NRC Questions from 10/22 (assigned to G. Pugh):

Question #36 (Request Number 42)

CRYSTAL RIVER UNIT #3

1.01.7 REACTOR BUILDING DESIGN-PRESTRESSING

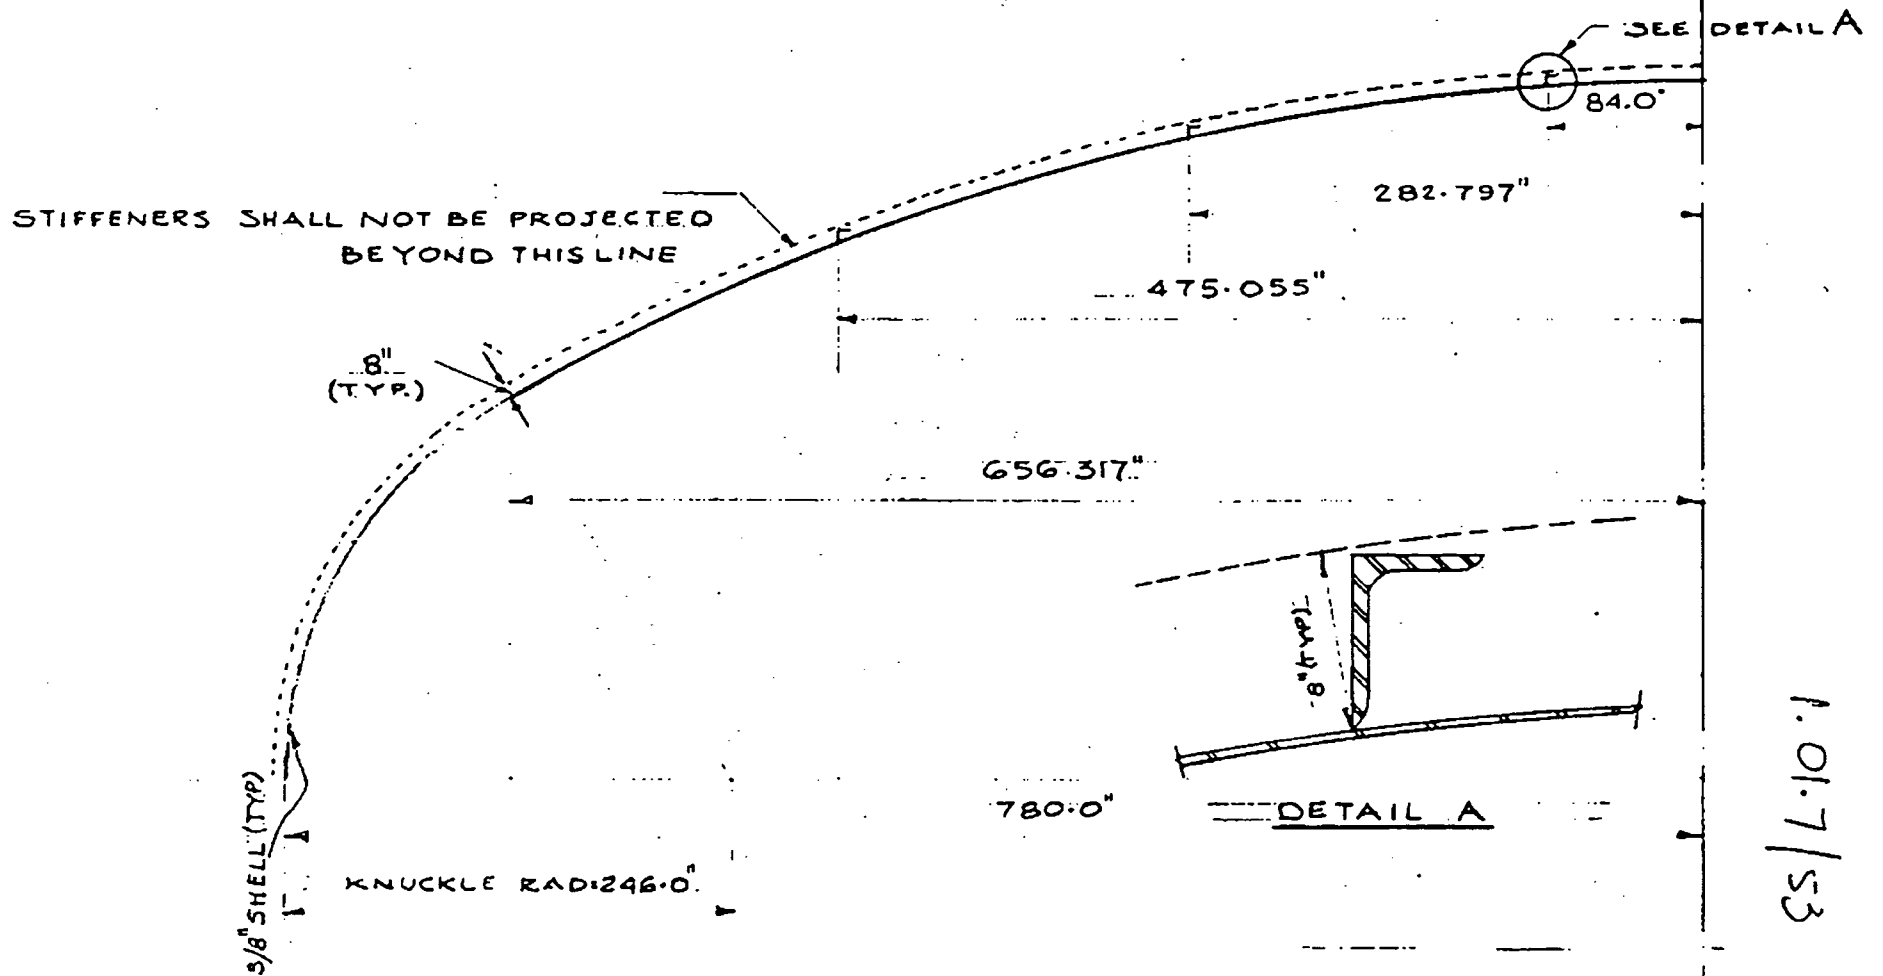
The horizontal legs of C-4 (2 L's 8 x 6 x 3/4 with a 10" x 1/2" R) also cause an interference and we ask that this stiffener be revised so that any projection normal to the surface of the dome does not exceed eight (8) inches.

Enclosed please find a sketch showing the preceding, and in the event that you should have any questions please feel free to contact us.
